## SITE BASED STORMWATER MANAGEMENT PLAN

Proposed Child Care Development  
Banya ELC Property One Pty Ltd ATF Banya ELC Property One Unit Trust  
Lot 8100 Musgrave Crescent, Banya

**AMENDED IN RED**

Approval no: **DEV-2026-CAS-4857**

CLIENT BANYA ELC PROPERTY ONE PTY LTD ATF BANYA ELC PROPERTY ONE UNIT TRUST  
PROJECT  
PROPOSED EARLY LEARNING CENTRE  
LOT 8100 MUSGRAVE CRESCENT, BANYA QLD 4551  
CIVIL WORKS PLAN

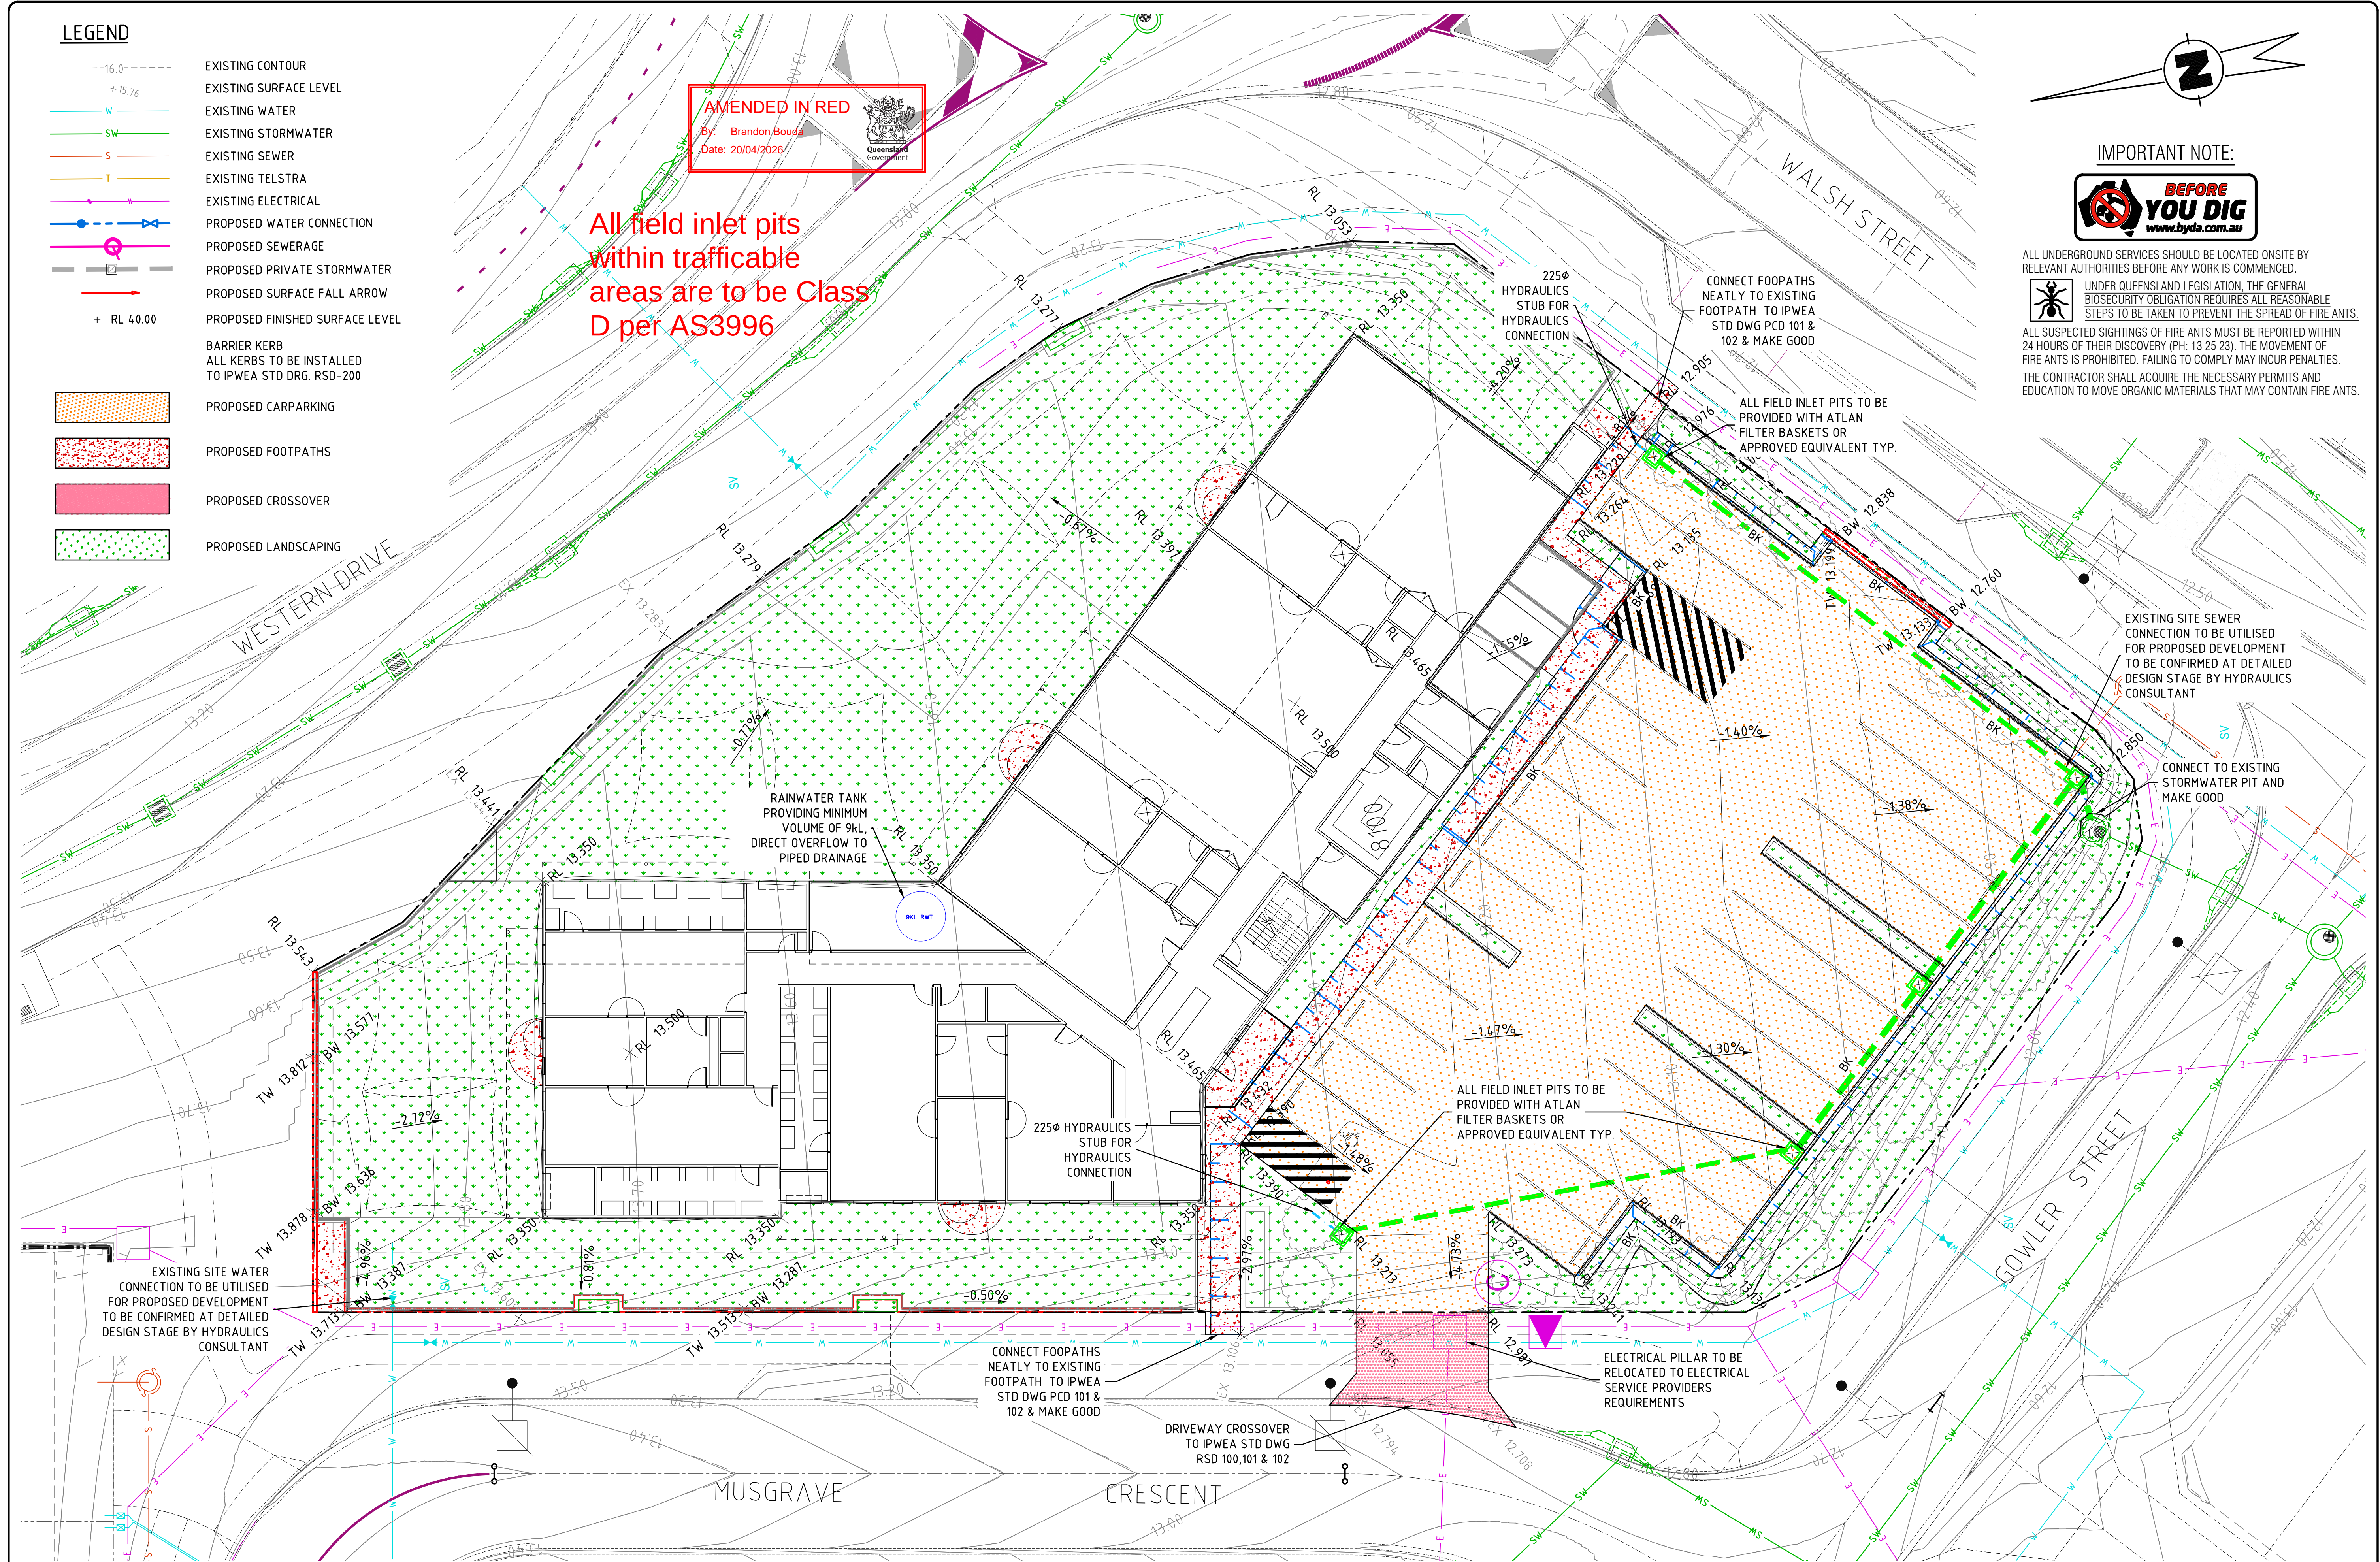
AMENDED IN RED

All field inlet pits within trafficable areas are to be Class D per AS3996
